Rossdale Transportation Network What We Heard Report

The Rossdale Transportation Network project is developing roadway and streetscape designs in the Rossdale area that will improve active transportation connections (walking, cycling and wheeling) and accommodate drivers travelling into and out of the Rossdale neighbourhood.

This report summarizes the input from Public Engagement Phase 1 from September to December 2021.

Design ideas: Rossdale Road between 97 Avenue and 105 Street.

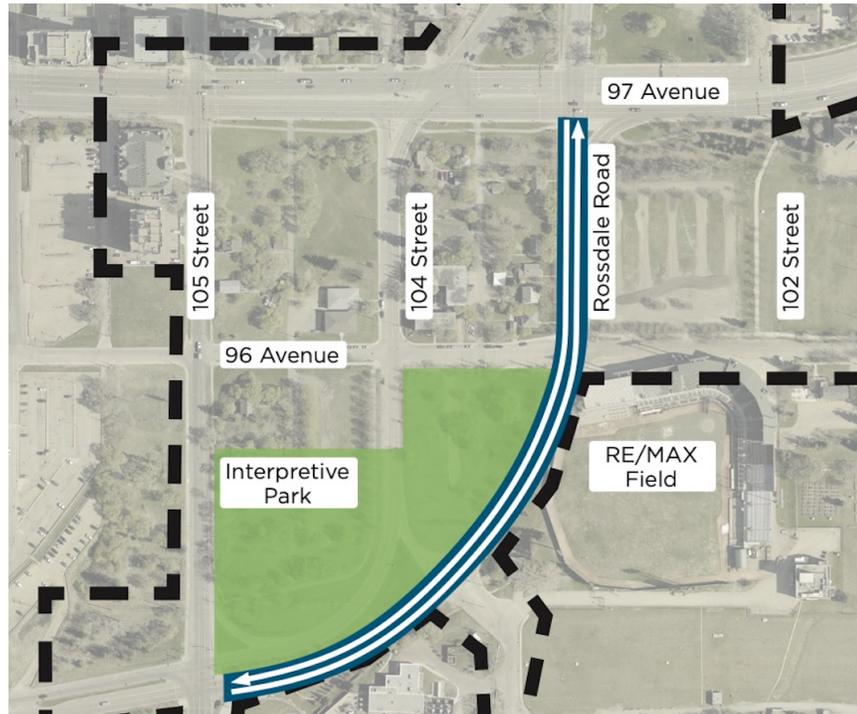
"This looks good. Rossdale Road never needed to be three lanes as most traffic forms a line in the right lane to turn right onto 97 Avenue."

"Make sure it is safe for cyclists. Include pedestrian overpasses where needed."

"Bikes do not belong on the road with vehicles."

"Get rid of the ridiculous bike lanes."

“This looks like a great start to improving what is currently a dangerous mess.”

“I’m afraid that it will be difficult to access that area if you cut public transit.”

“This is going to be a nightmare for residents that will likely make our apartments less affordable in the long run. So please be patient with us if it seems like we don’t want this.”

Respondents favour prioritizing active transportation (walking, biking and wheeling) along Rossdale Road and highlight the need to ensure safety for all users. There is a desire to consider the experience of those who walk and bike by ensuring sidewalks and paths are wide enough, separating both bikes and pedestrians from cars, and providing lighting and safe crossings. Both 96 Avenue and 97 Avenue were highlighted as priorities for safe crossings.

There is support for the idea of making Rossdale Road into a two-way road. Many respondents indicated two lanes in each direction is preferred to reduce congestion in the area during peak times.

Design ideas: Bellamy Hill / 97 Avenue / Rossdale Road / 103 Street intersection.

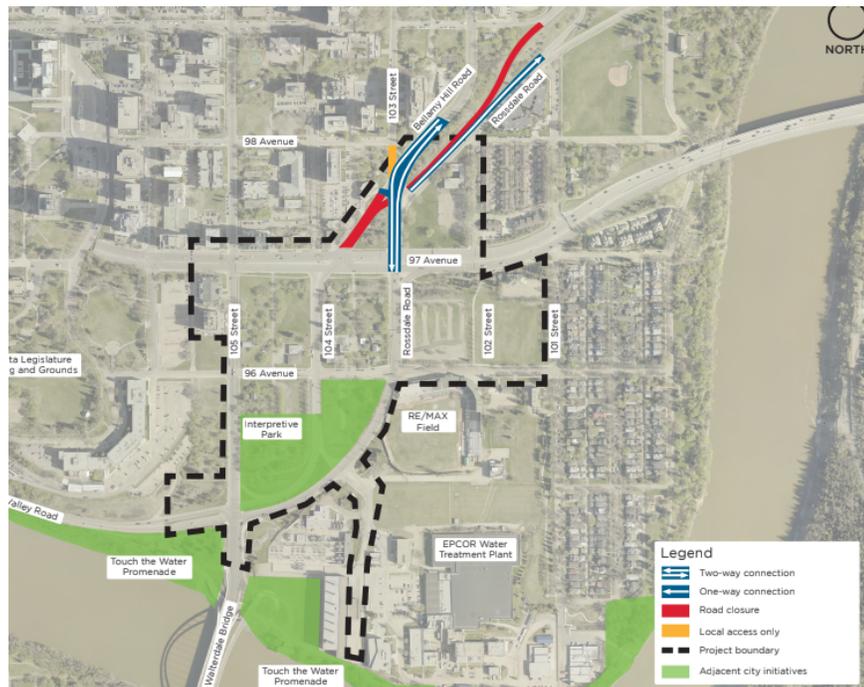
There is support for the design ideas from those who believe the changes will eliminate confusion for drivers and others who move

through this complex intersection, ultimately improving traffic flow.

Those who are not supportive share concerns that the design will impede traffic flow and increase congestion ultimately negatively impacting downtown. The closure of the access to 103 Street is noted as the removal of a major route for drivers exiting downtown.

There are also concerns that the design will limit or remove access to some of the residential buildings in the area.

Respondents again voice a desire to prioritize active transportation (walking, biking, wheeling) separate bikes from cars. Others call on the City to prioritize cars.

Design ideas: 102 Street between 97 Avenue and 96 Avenue.

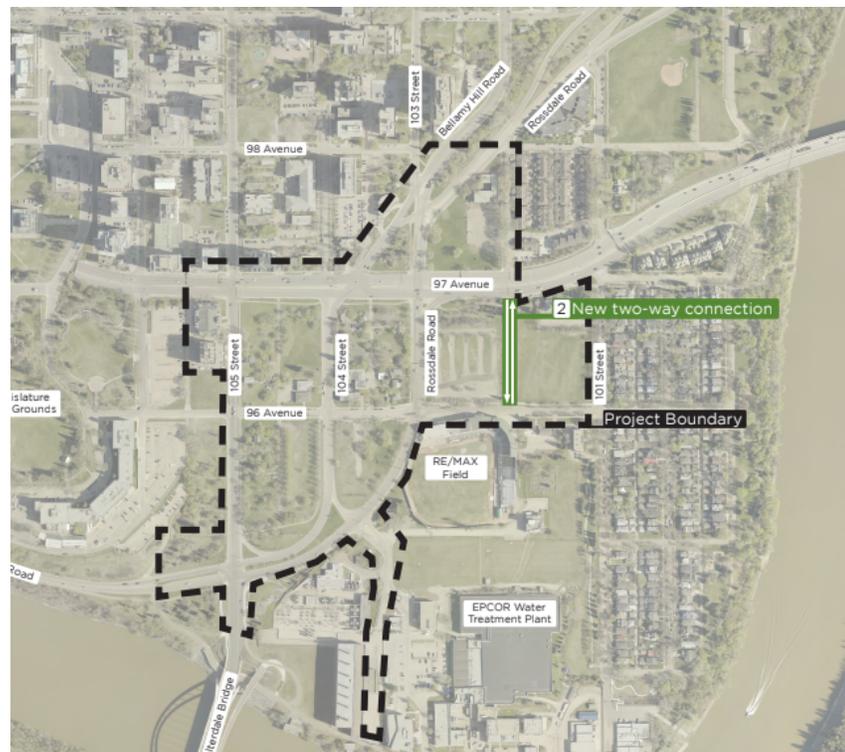
"A fantastic idea that will help catalyze new development in the area. As someone who spends a lot of time in the area, I can't wait to see new development, shops and restaurants in the area! Traffic calming will be critical for this road."

"I don't think a road is needed here. This should be park space."

"I do not approve of opening 102 Street to cars. The pedestrian/bike path needs to remain untouched, although it could do with improvements."

Confusion exists about the need and rationale for this new roadway therefore, many respondents suggest that the area should be left the way it currently is, without the new road.

There is support for the idea of a shared street, as well as a desire by some to prioritize active transportation (walking, biking and wheeling) and completely close the street to cars. However, if cars are allowed, respondents feel that the transportation modes should be separated from each other meaning cars and bikes and pedestrians should each have their own spaces.

Concerns include that the new 102 Street will lead to shortcutting and provide an unwelcome access into the Rossdale neighbourhood and that the addition of traffic signals at the intersection of 97 Avenue and 102 Street will cause vehicles to back up along 97 Avenue, which is a major east/west connection causing traffic delays. Respondents indicate any changes to this area should not impede vehicular traffic flow.

Design ideas: 96 Avenue between 105 Street and 101 Street.

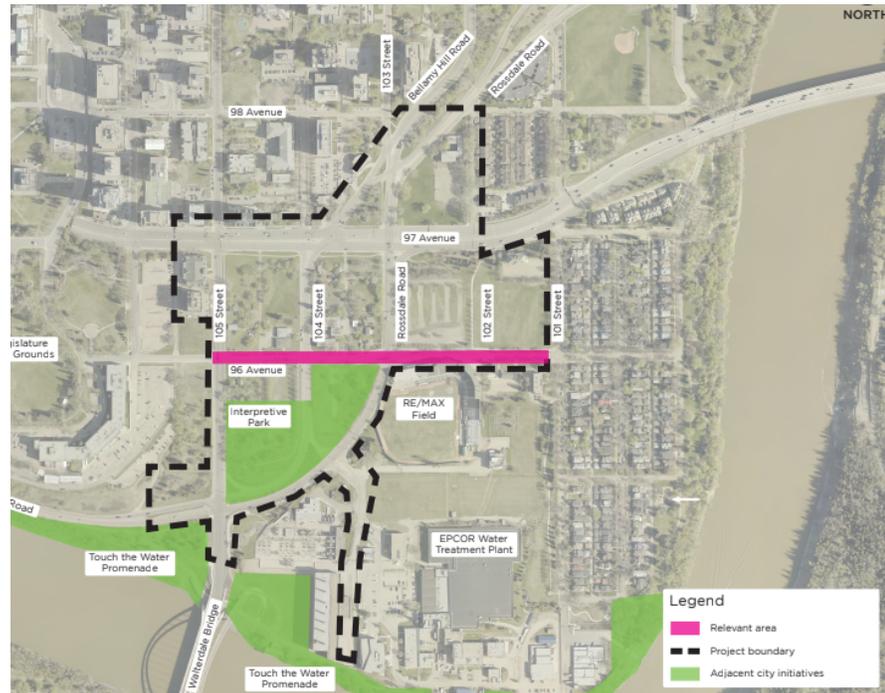
"I do not support this area becoming a retail destination. I do not consider it to be appropriate or sustainable in the long term."

"Traffic calming will be critical to ensure the roadway is usable for everyone and doesn't just become a 'shortcut' for commuters."

Respondents offer general support for the proposed design ideas with a desire to prioritize active transportation (walking, biking, wheeling) and to ensure that appropriate connections are provided for cyclists to link to key destinations and the broader bike network.

Some respondents, who wish to prioritize cars, do not support the design ideas while others suggest potentially closing the road to cars completely.

Respondents note that for retail and commercial businesses to be viable, they must be appropriately supported which includes both vehicle parking and active mode connections.

There are concerns about traffic flow and congestion as a result of this design and respondents ask the City to consider impacts on the overall vehicle network, access to Rossdale neighbourhood and vehicle and pedestrian traffic following events and activities at ReMax Field and other locations in the area.

Design ideas: Rossdale Power Plant / Water Treatment Access.

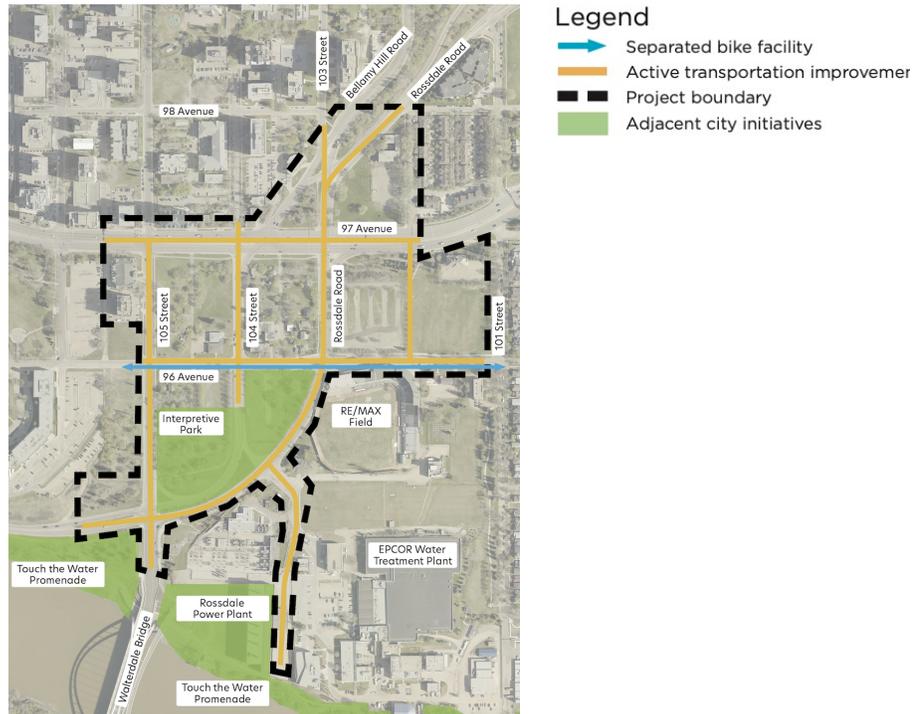
“A public access road here will help bring people down to the waterfront.”

“This is a perfect connection to the multi-use trail that runs along the river. Ensure that it is connected.”
